**Addendum No. 1**  
**March 6, 2025**

Project: Brandon Valley Middle School Addition  
Brandon, South Dakota  
Project #3090

Architect: Architecture Incorporated

4.10B

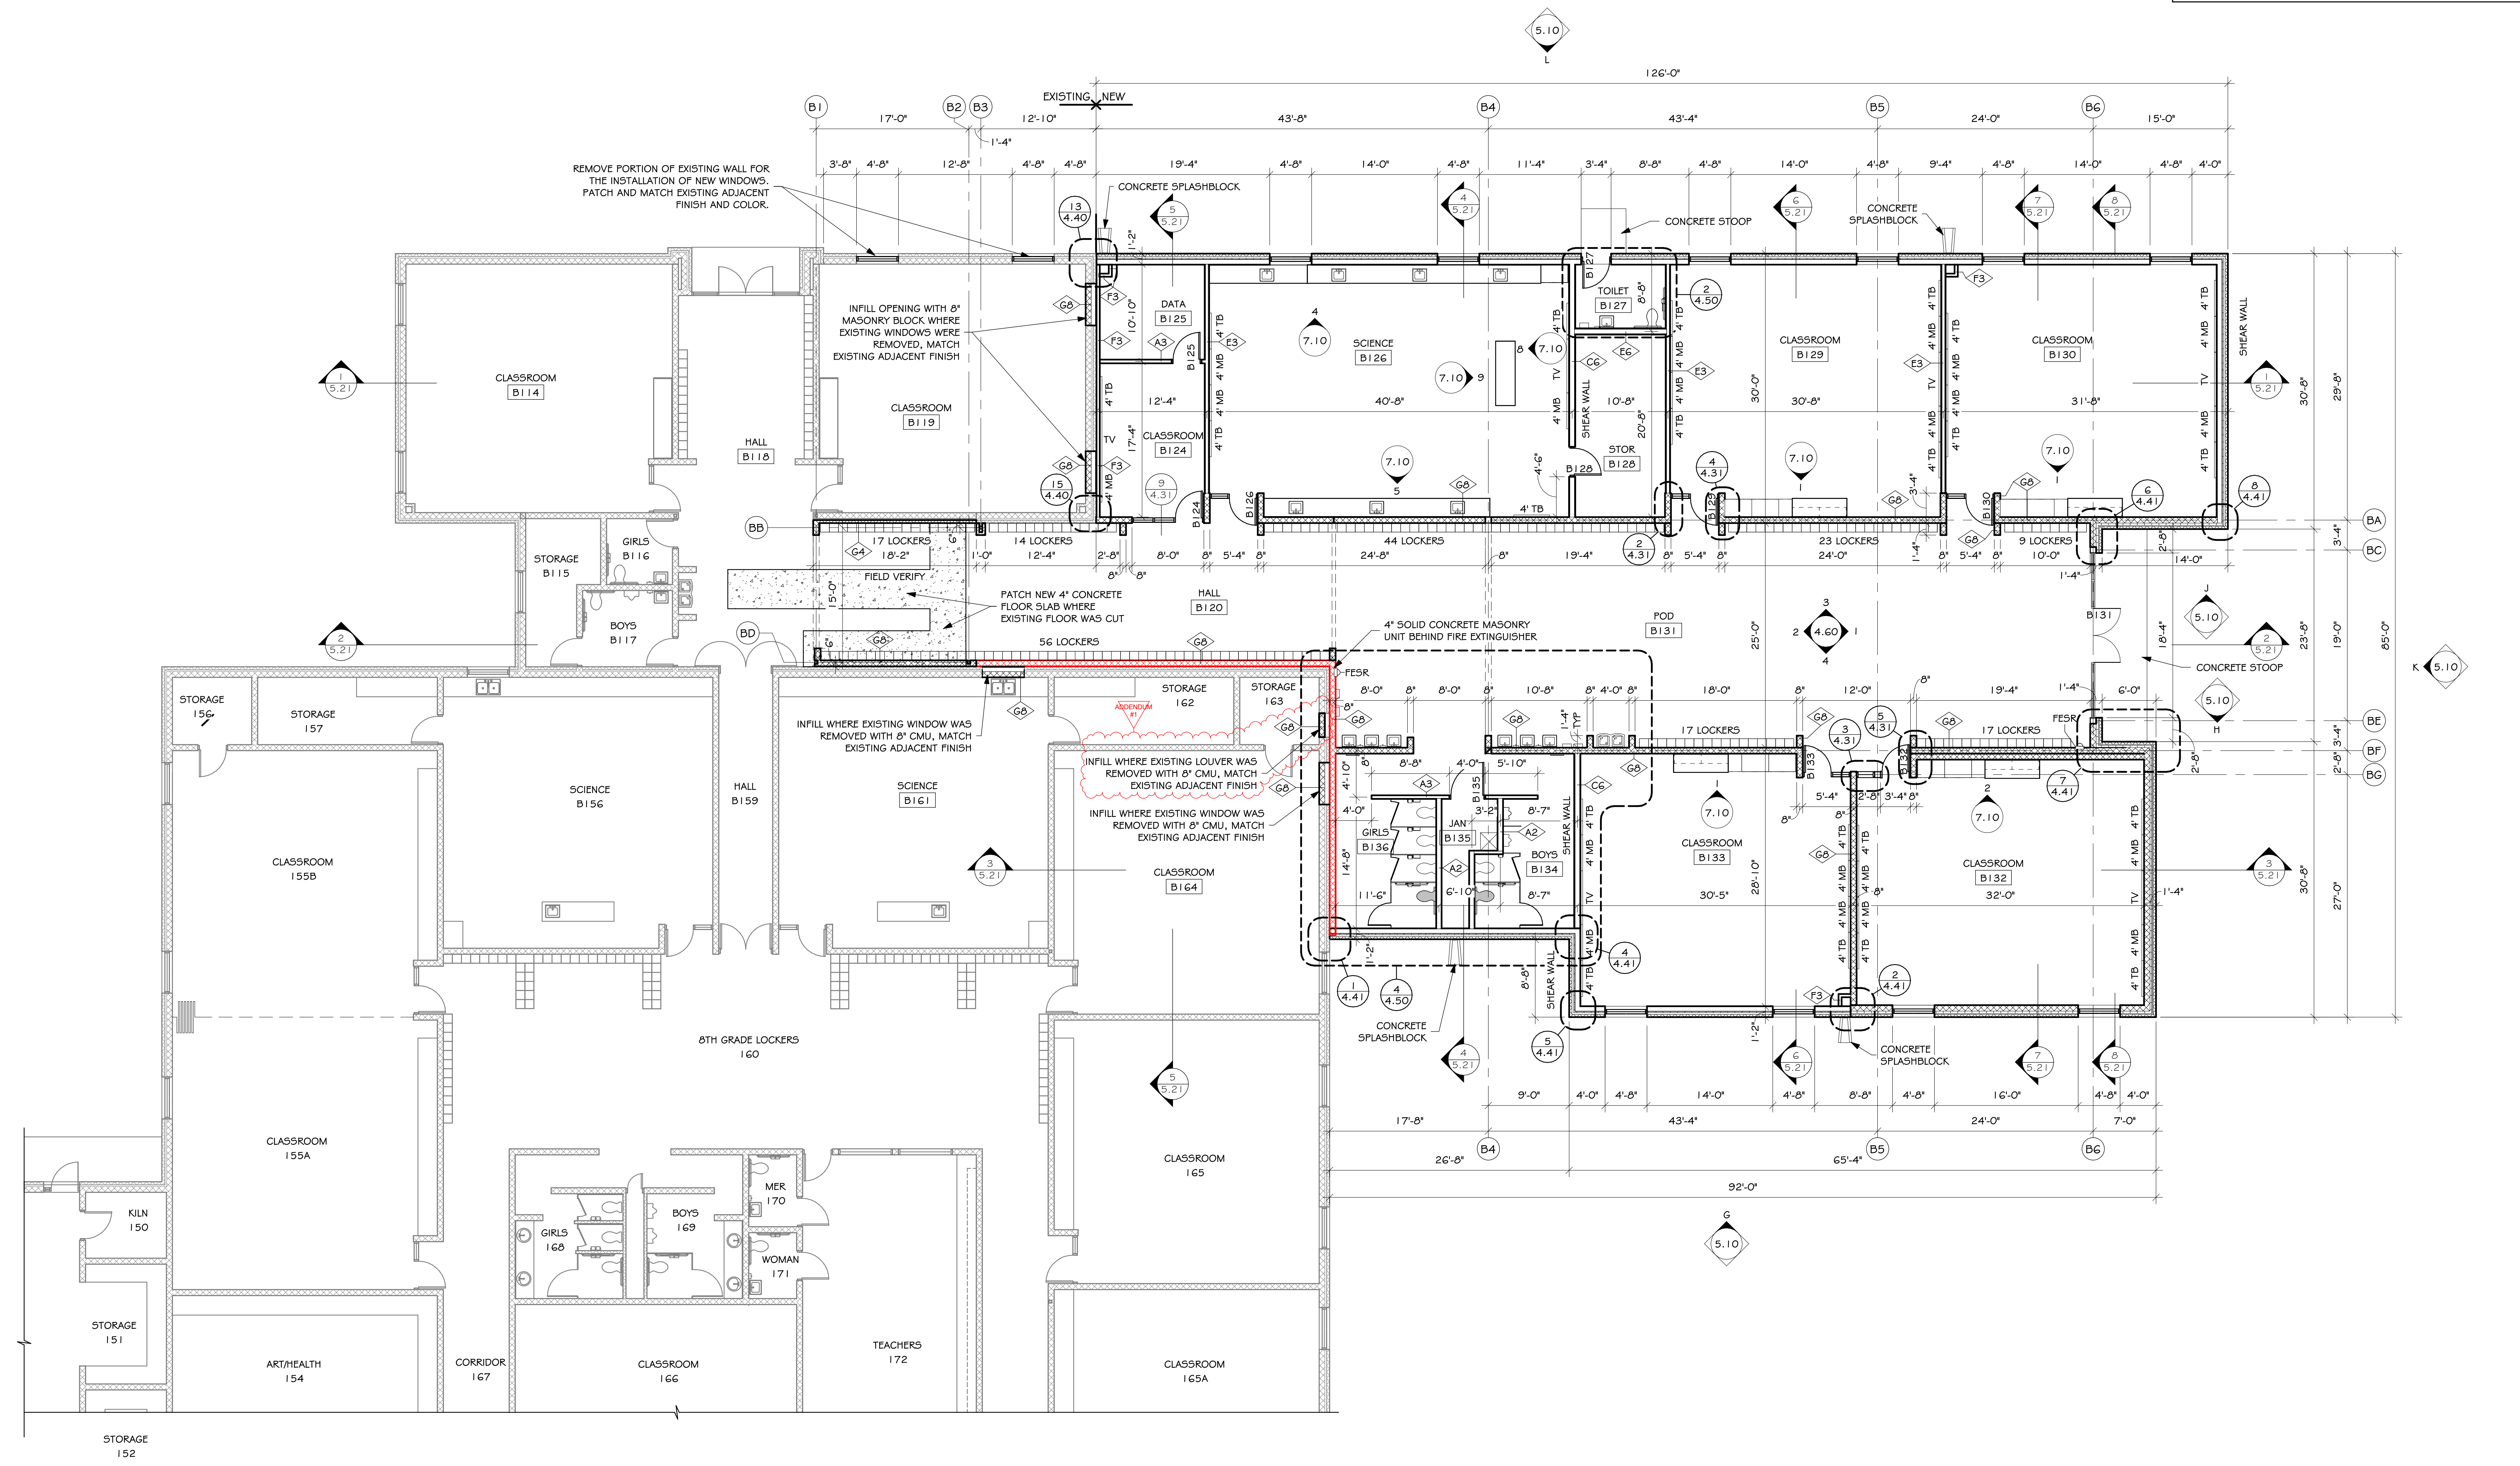
- 5) SHEET 4.10B – FLOOR PLAN – AREA B
  - a) The east wall of Storage 163 shall be in-filled with 8” CMU where the existing louver is removed.
    - i) Reference *revised* Sheet 4.10B, dated 3-6-2025, attached to the end of this addendum.

4.10D

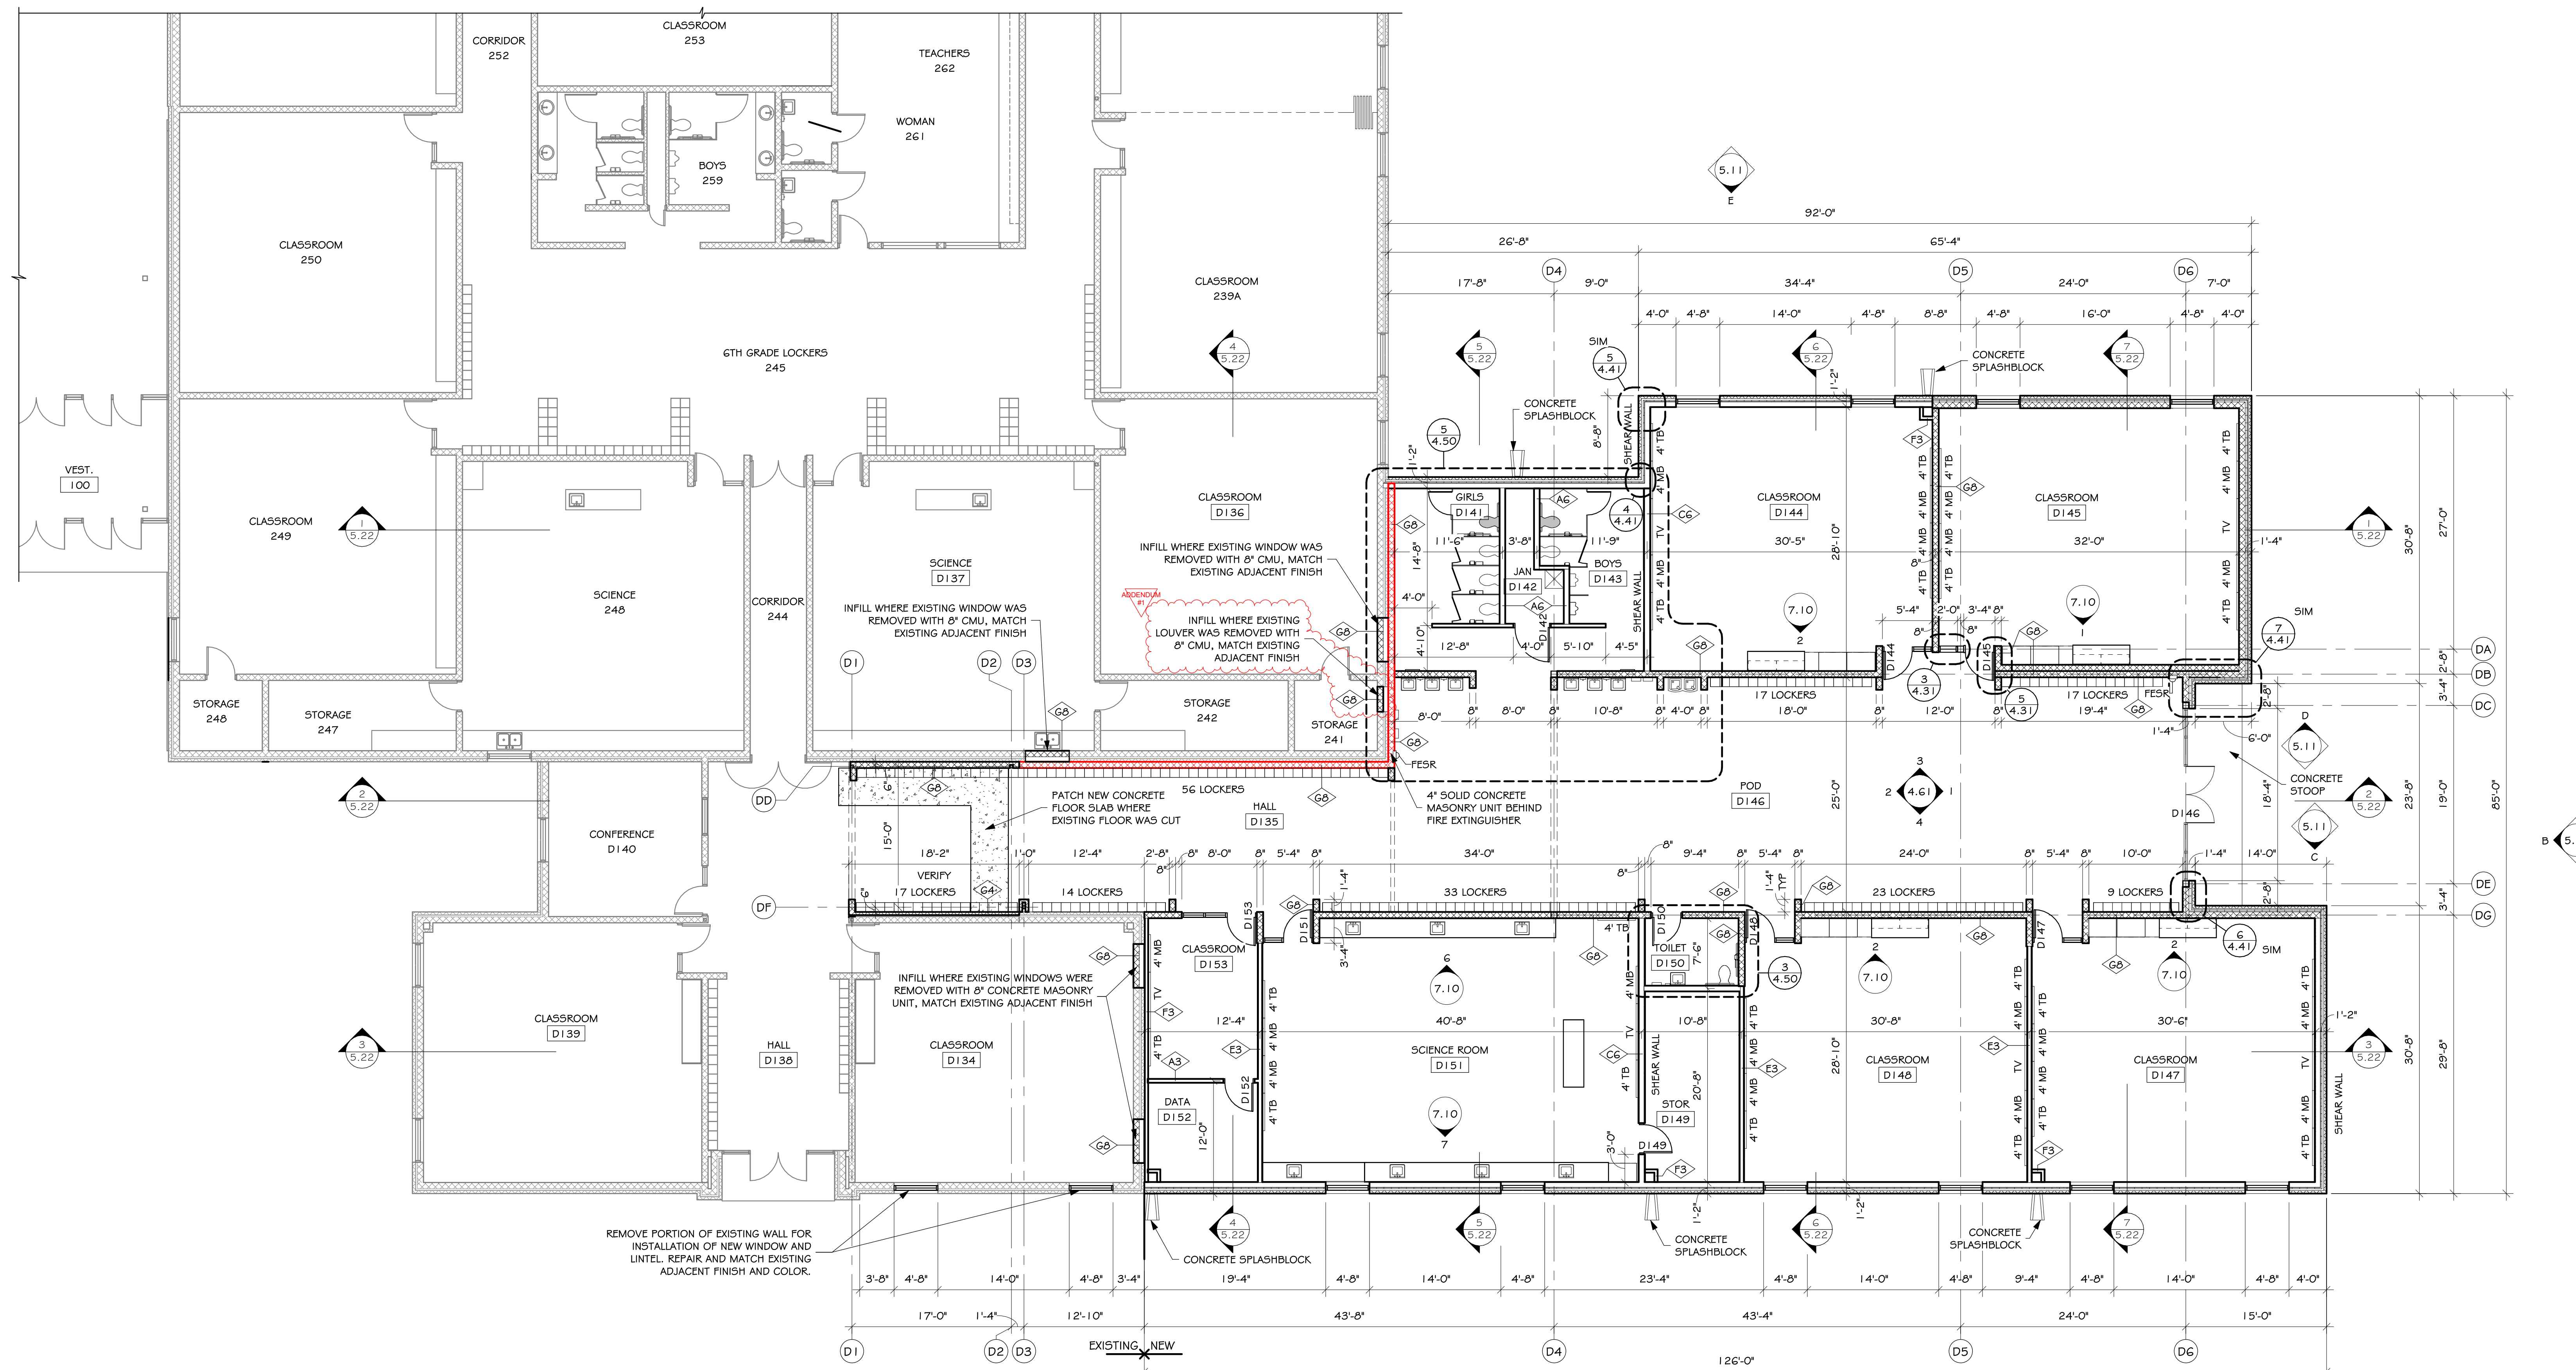
- ii) See Mechanical Demo Plan (Sheet 8.23) for location of louver to be removed.
- 6) SHEET 4.10D – FLOOR PLAN – AREA D
  - a) The east wall of Storage 241 shall be in-filled with 8” CMU where the existing louver is removed.

- i) Reference *revised* Sheet 4.10D, dated 3-6-2025, attached to the end of this addendum.
    - ii) See Mechanical Demo Plan (Sheet 8.23) for location of louver to be removed.
